APPLICATION OF NEW CINGULAR WIRELESS
PCS, LLC (AT&T) FOR A CERTIFICATE OF
ENVIRONMENTAL COMPATIBILITY AND PUBLIC
NEED FOR THE CONSTRUCTION, MAINTENANCE
AND OPERATION OF A TELECOMMUNICATIONS
TOWER FACILITY AT 522 COLEBROOK ROAD
IN THE TOWN OF COLEBROOK

DOCKET NO. 440

NEW CINGULAR WIRELESS PCS LLC (AT&T)
SUPPLEMENTAL INFORMATION

Wetlands Delineation Map

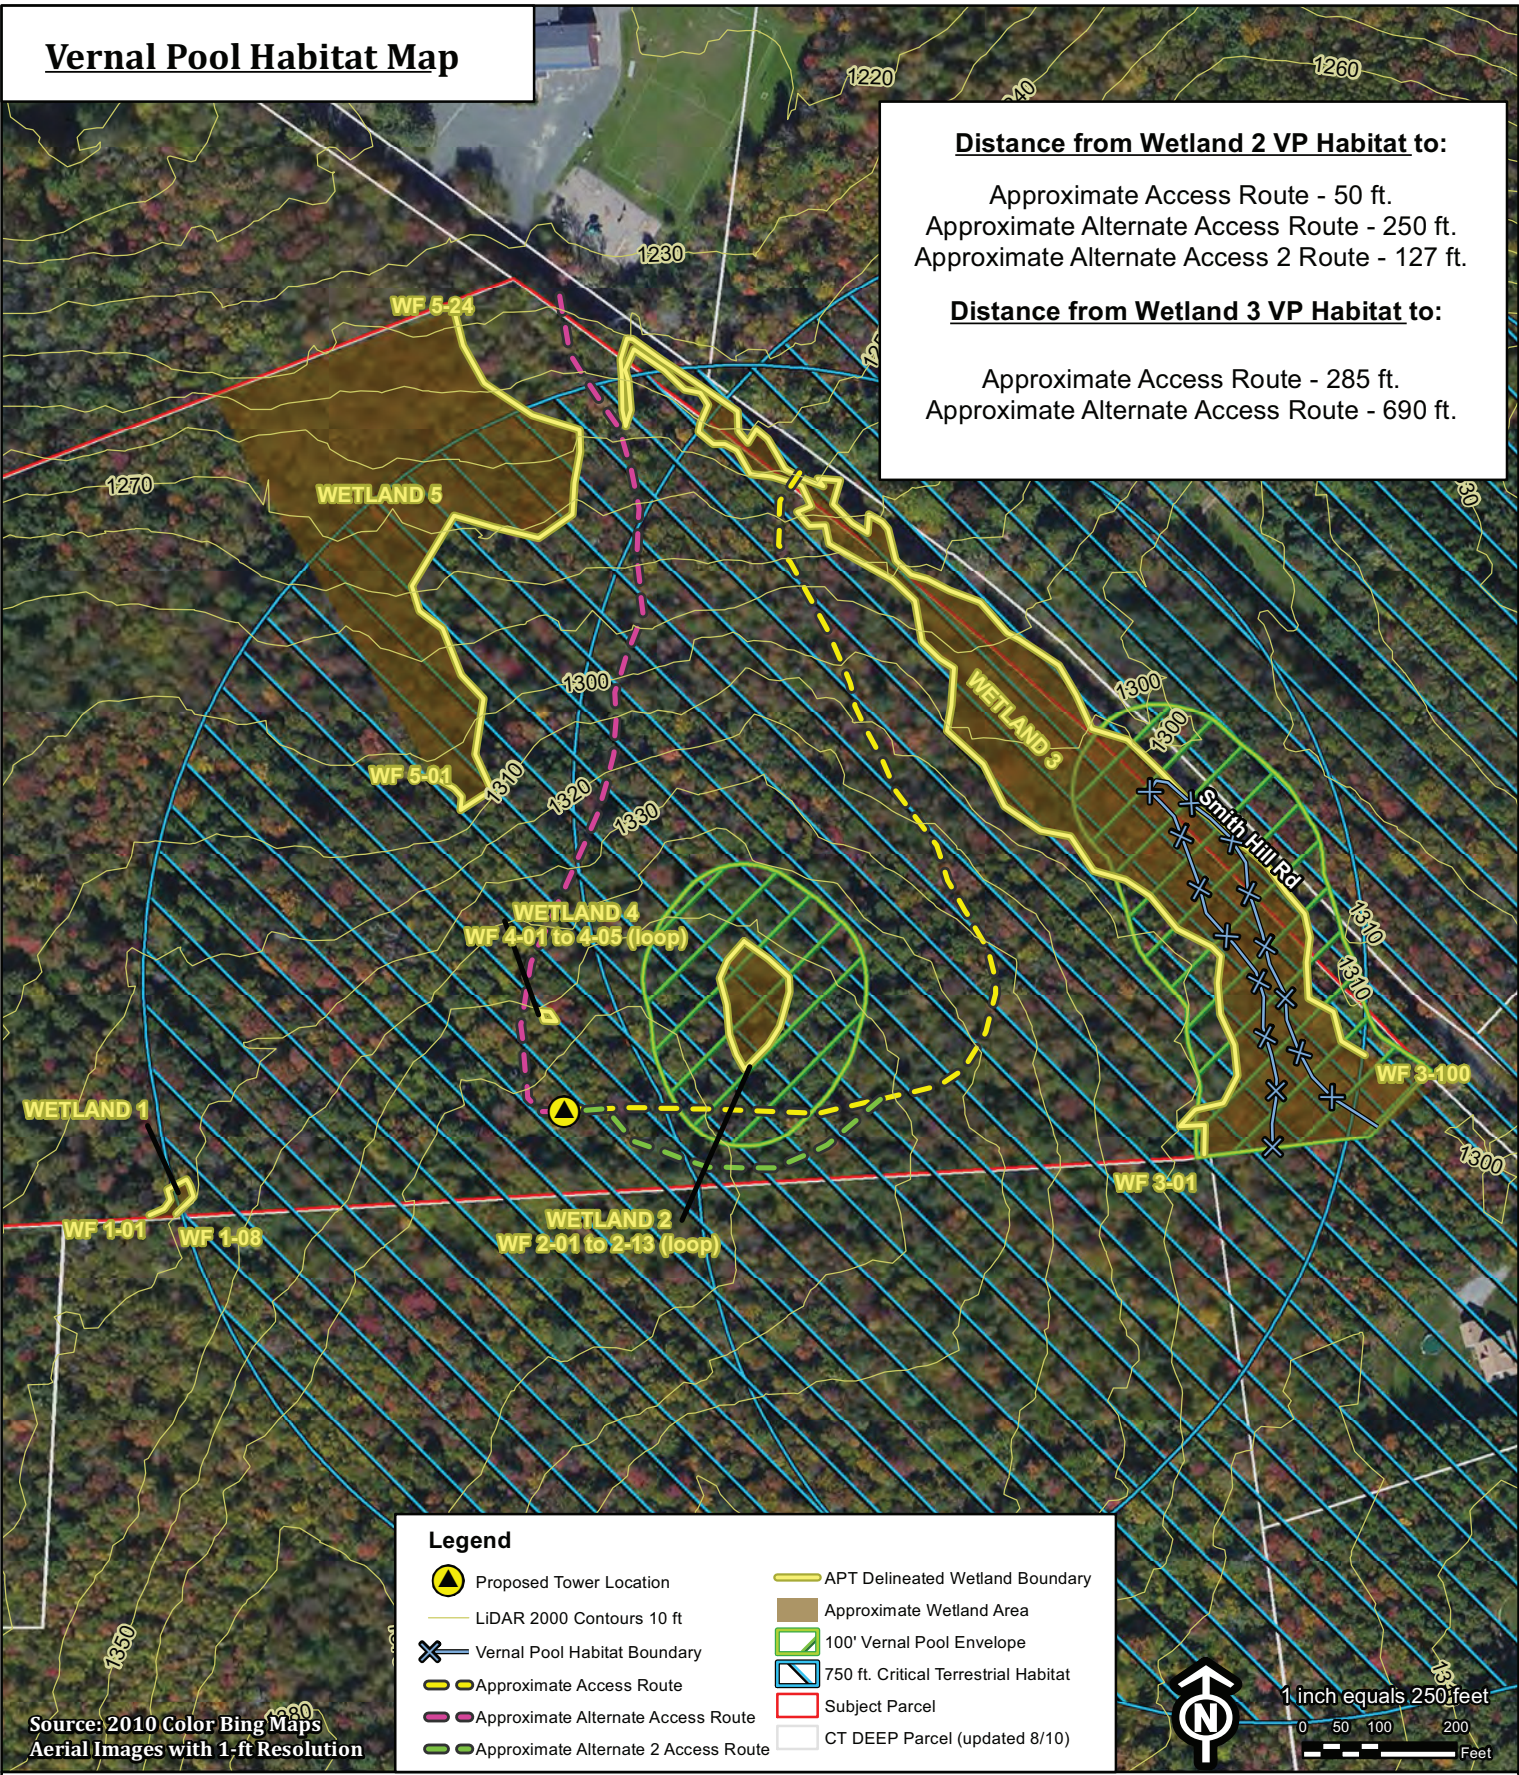
- Q1. Would it be possible to swing the access road to the west to avoid Wetland 1?
- A1. Yes. AT&T's consultants conducted additional field review to delineate wetlands on the western portion of the site and to determine if an alternative access drive was feasible. Included in Attachment 1 is a preliminary wetlands map depicting the additional wetlands delineation along with a proposed alternative access drive shown as a pink dashed line. As shown in the attached map, the alternate access drive avoids direct impacts to wetland 3 as well as providing a large buffer to wetland 3. The alternative access drive is approximately 250' shorter than the proposed access drive. Moreover, grades for the alternate access drive are comparable to the grades of the proposed access drive.
